MONTGOMERY COUNTY PLANNING DEPARTMENT
 THE MARYLAND-NATIONAL CAPITAL PARK AND PLANNING COMMISSION

MEMORANDUM

REVIEW TYPE: Preliminary Plan of Subdivision (Resubdivision)
APPLYING FOR: Three lots for three one family residential units

PROJECT NAME: Muncaster Manor
CASE NO. 120070660
REVIEW BASIS: Pursuant to Chapter 50, the Subdivision Regulations

PRELIMINARY PLAN

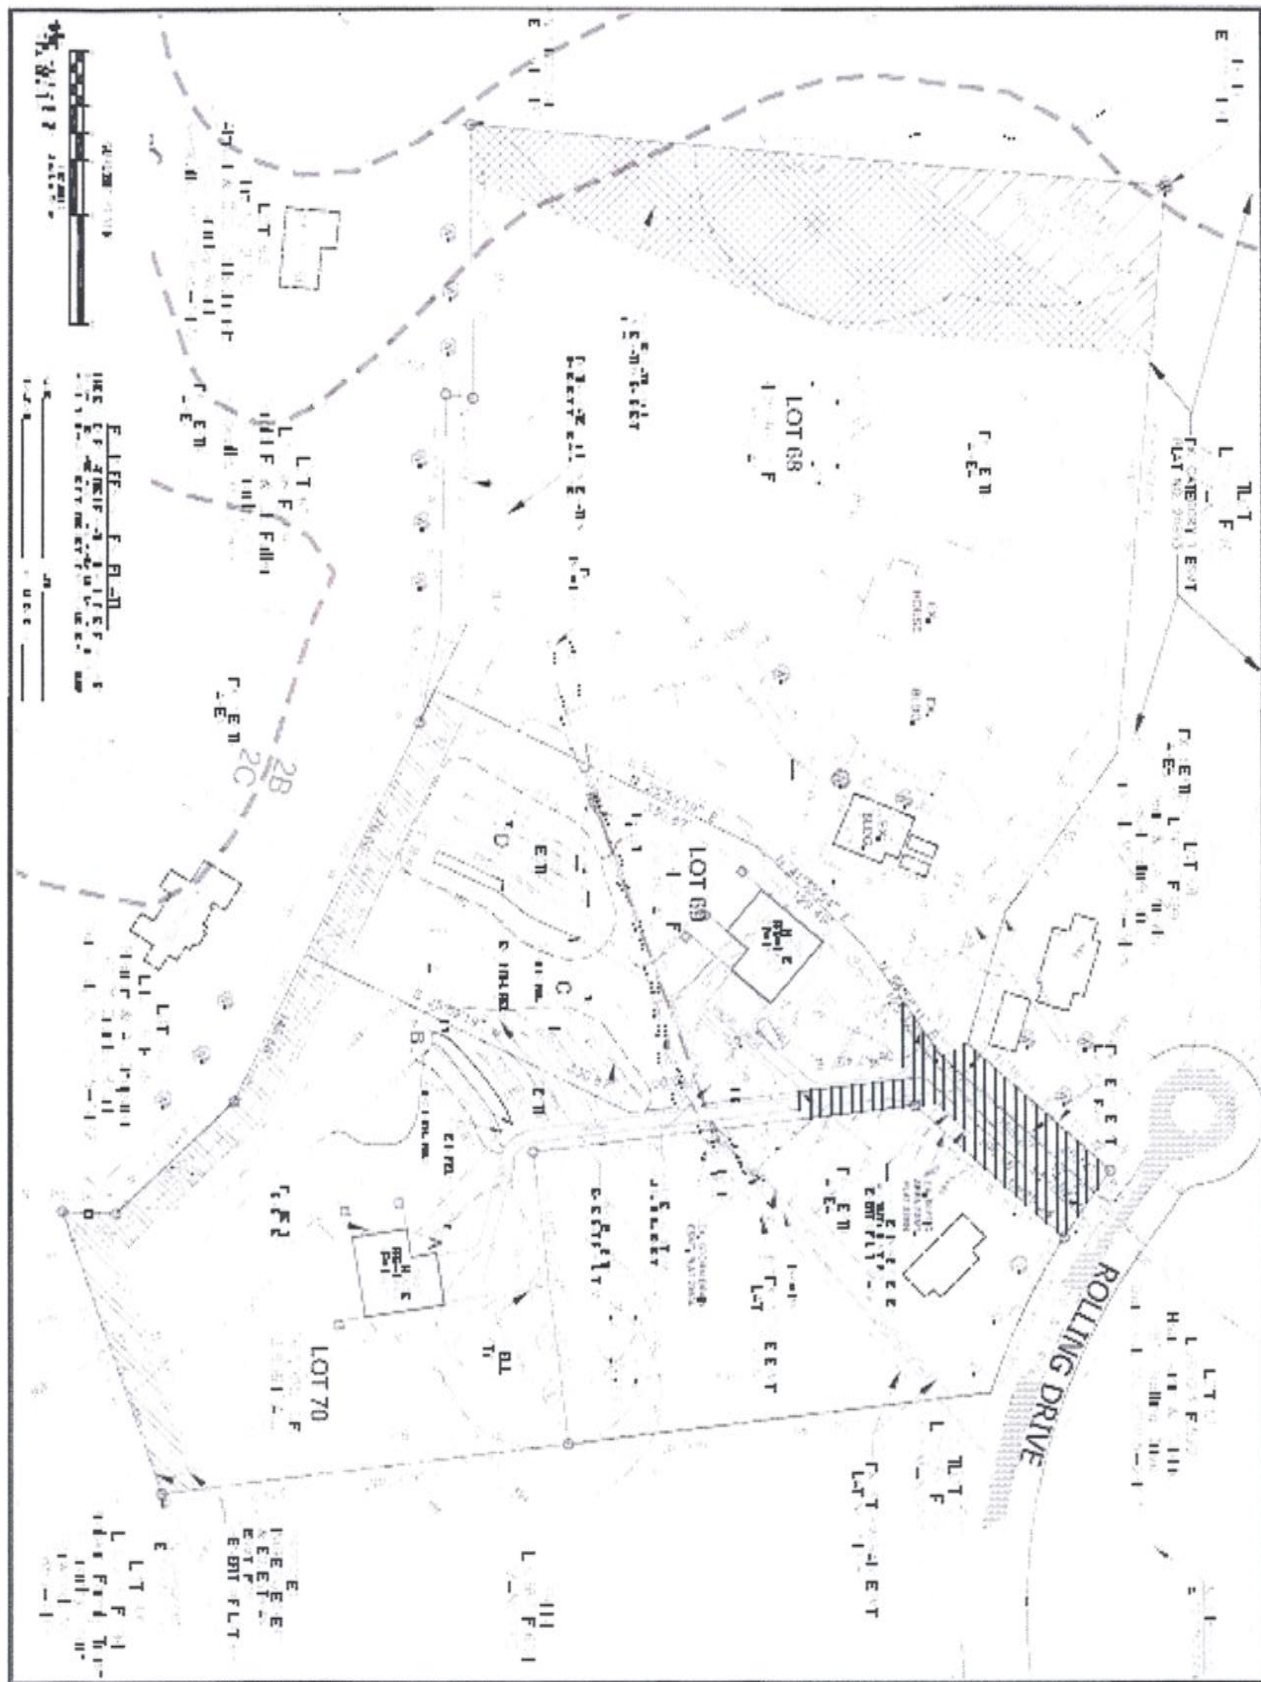
This request is to resubdivide Lot 66 into three lots; two for new one family residences and the largest lot will continue to operate as an equestrian facility, with the existing house remaining. The new homes will access the existing driveway that now serves the equestrian facility but it will be widened to accommodate fire and rescue equipment. All of the homes in this subdivision will be served by private on-site wells and septic systems. Rolling Drive has a 60 foot wide right-of-way and has been improved to secondary street standards. No sidewalks are built along Rolling Drive, and none are proposed as part of this plan.

Size: Existing lots in the delineated Neighborhood range from 2.60 acres in size to the largest at 5.95 acres in size. The proposed lots will be 2.97 acres and 3.85 acres, with the equestrian facility remaining on a 9.32 acre lot. The equestrian lot is currently the largest in the Neighborhood; this resubdivision reduces it in size but it will remain as the largest. The proposed lot sizes are in character with the size of existing lots in the Neighborhood.

Width: Existing lots in the delineated Neighborhood range from 165 feet to 541 feet. All proposed lots are within this range. The proposed lots will be in character with existing lots in the neighborhood with respect to width.

Frontage: The frontages for the existing lots in the delineated Neighborhood range from 0 feet to 598 feet. All three proposed lots will have frontages of 25 feet creating pipestem lots. There are five other pipestem lots in the Neighborhood with frontages of: 0 feet, 28 feet, 31 feet 33 feet and 40 feet. Typically pipestem lots will have frontages of 25 feet, the minimum allowed by the Zoning Ordinance without specific findings by the Planning Board for less frontage. In staff's opinion, the three proposed lots with frontages at 25 feet each will be out of character when compared to the other pipestem lots that have varying frontage measurements. The proposed lots will be of the same character as existing lots in the neighborhood with respect to lot frontage.

Area: Buildable areas for the existing lots in the Neighborhood range from 1.79 acres to 4.58 acres. The buildable areas for the proposed lots will range from 2.09 acres to 6.49 acres; again, the equestrian lot will be the largest in the Neighborhood as it currently is. The proposed lots will be of the same character as other lots in the neighborhood with respect to buildable area.

Alignment: The alignment characteristics of the existing lots in the Neighborhood vary widely. Some lots, as is the case for those lots abutting the Subject Property to the south, are removed by a considerable distance from the streets to which they front. Their alignment is generally perpendicular to the street as are the three proposed lots. Staff finds that, with respect to the alignment of the proposed lots, they are of the same character with the general alignment characteristic of the Neighborhood.

Shape: Existing lots have a variety of lot shapes that are best described as rectangular, trapezoidal, wedge, and flag (pipestem). The shapes of the proposed lots can be described as pipestem, similar with the shapes of several other existing lots in the Neighborhood. Therefore, they are of the same character with respect to shape.
